City of Santa Fe, New Mexico

2051 CERROS ALTOS TERRAIN MANAGEMENT VARIANCE

Case #2016-06. 1503 Cerros Altos Terrain Management Variance. Sommer, Karnes and Associates, LLP, agent for Julie Silverstein Trust and the Kim M. Colweck Trust, requests a variance to the Terrain Management Regulations (Subsection 14-8.2(D)(3)(b)) to construct a single family residence. The applicant is requesting a variance to have more than one-half of the building footprint in natural slopes of greater than 20%. The property contains both Foothills and Ridgetop Subdistricts of the Escarpment Overlay Zone. The property is 4.337 acres and is zoned R-1 (Residential – 1 unit per acre). (Katherine Mortimer, Case Manager)

EXHIBIT D5

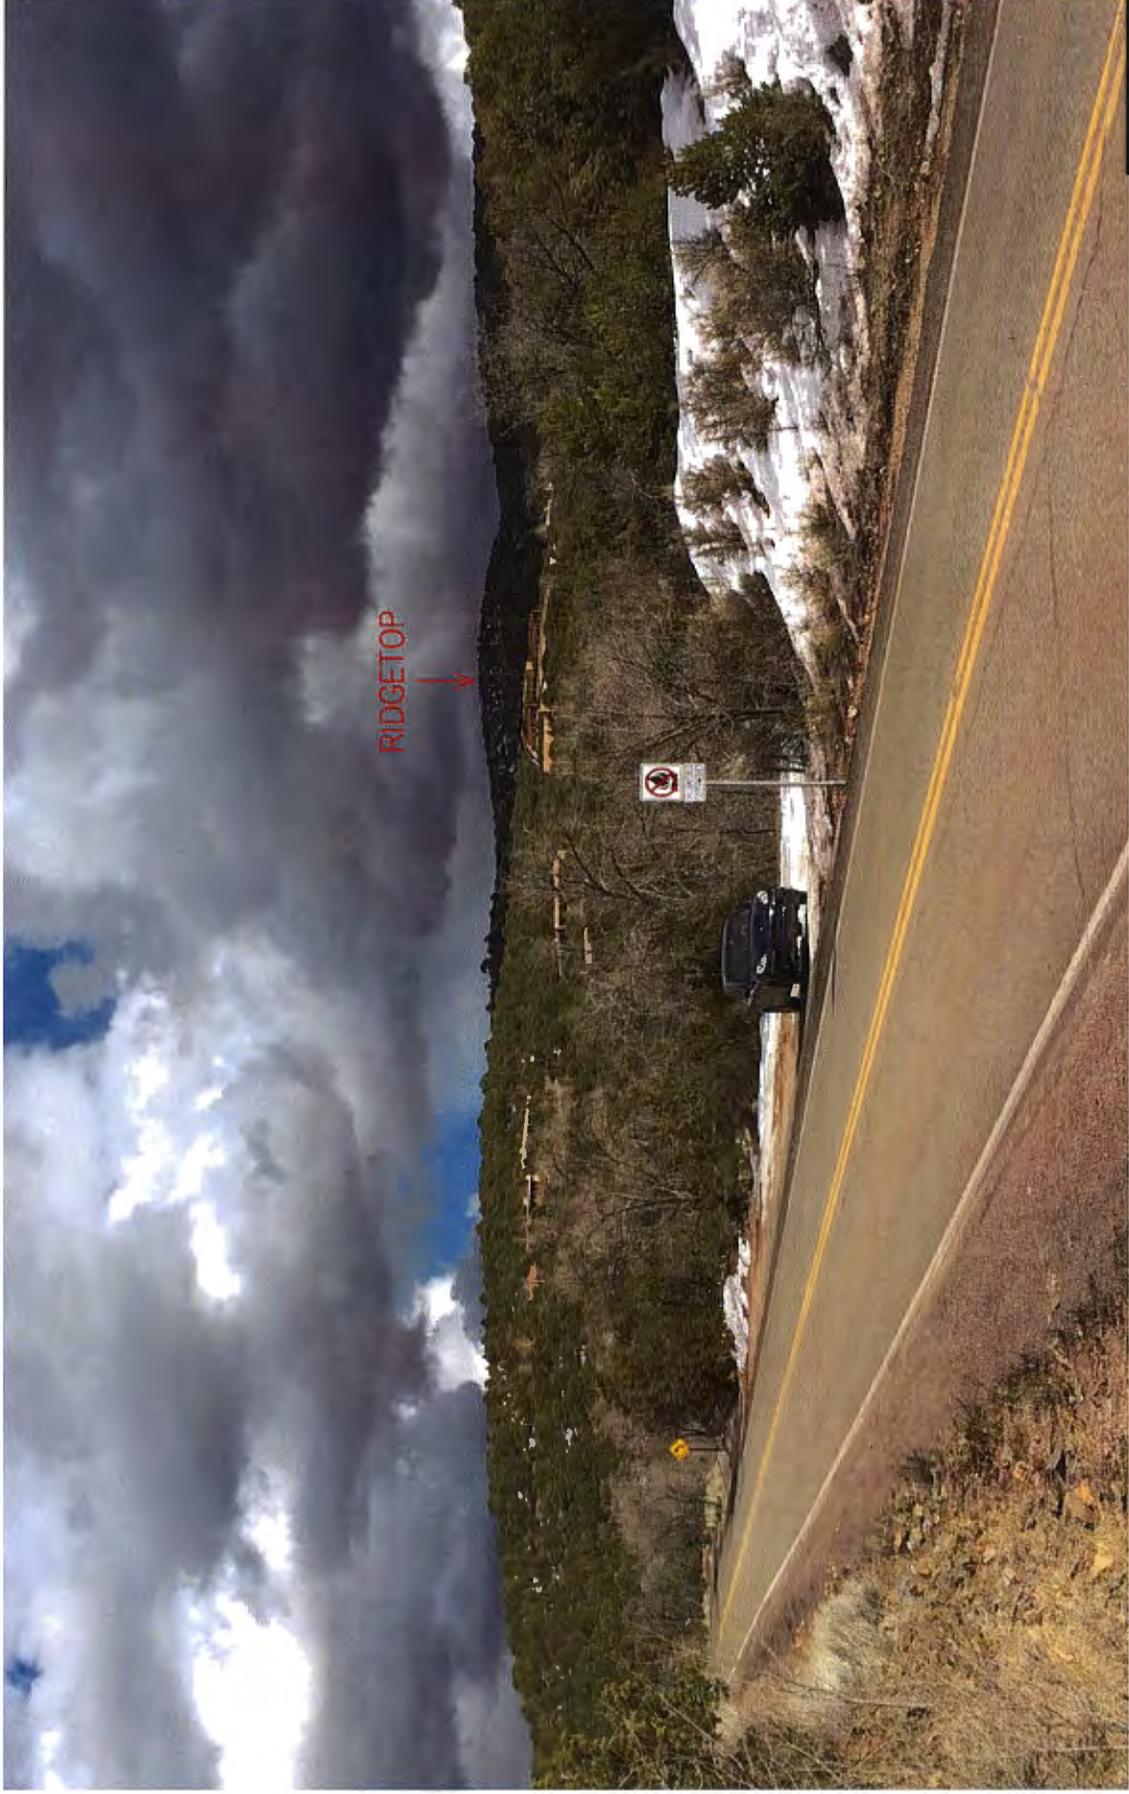
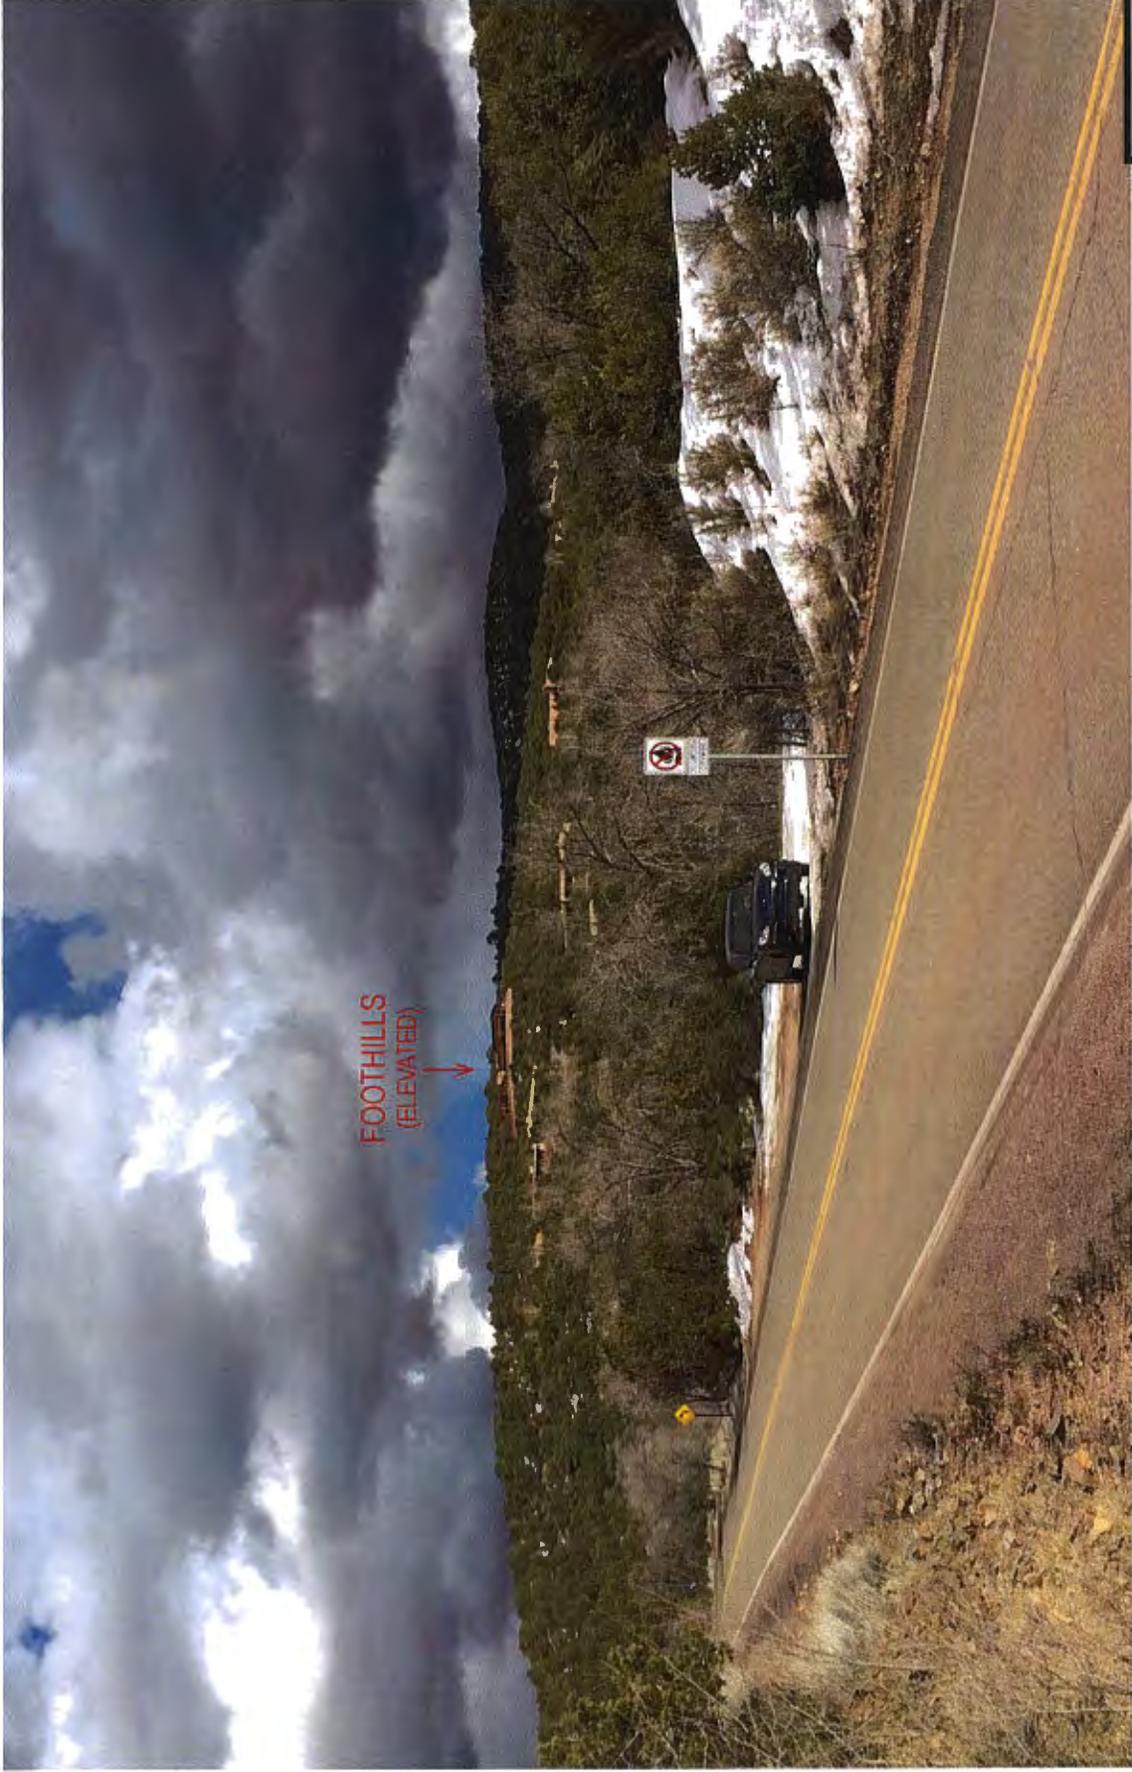
The applicant has provided photo renderings comparing the proposed location to an alternate location, as viewed from the two public roadways where the site is visible. (See Exhibit D) The alternate location would shift the footprint onto a flatter part of the site – avoiding the "50-50" variance – but would encroach into the Ridgeline Subdistrict. The renderings show that the home would not visually break the plane of the ridgeline as seen from public roads if located on the proposed location (Foothills). At the Ridgetop Subdistrict location, the home would visually extend above the ridgeline when viewed from Hyde Park Road. The proposed siting of the building is located away from the viewline as directed by SFCC §14-5.6(D).

Exhibit D includes photo renderings of the proposed home if it were moved northward to reduce the percentage of the footprint located on slopes less than 20%. These demonstrate that development on this site would result in public views of the building where the home would visually extend higher than the plane of the ridgeline, which is contrary to the intent of the Escarpment Overlay District.

If the building were moved northwards into the portion of the buildable area with slopes under 20% it would reduce the amount of the building footprint on slopes greater than 20% even if it wouldn't achieve a 50-50 ratio as required by the terrain management regulations. However, it would increase the overall amount of grading on the site and would increase the height of the top of the building and, as noted earlier and demonstrated in Exhibit D, would result in greater visual impacts conflicting with the intent of the Escarpment Overlay Zone.

Therefore, while moving the building to the north would technically reduce the amount of variance requested, it may be less in keeping with the full range of intent of the code when considering the escarpment overlay purpose and intent.

terrain management impacts. The photo renderings show that were an escarpment variance be granted, the home would not meet the intent of the Escarpment Overlay Zone.
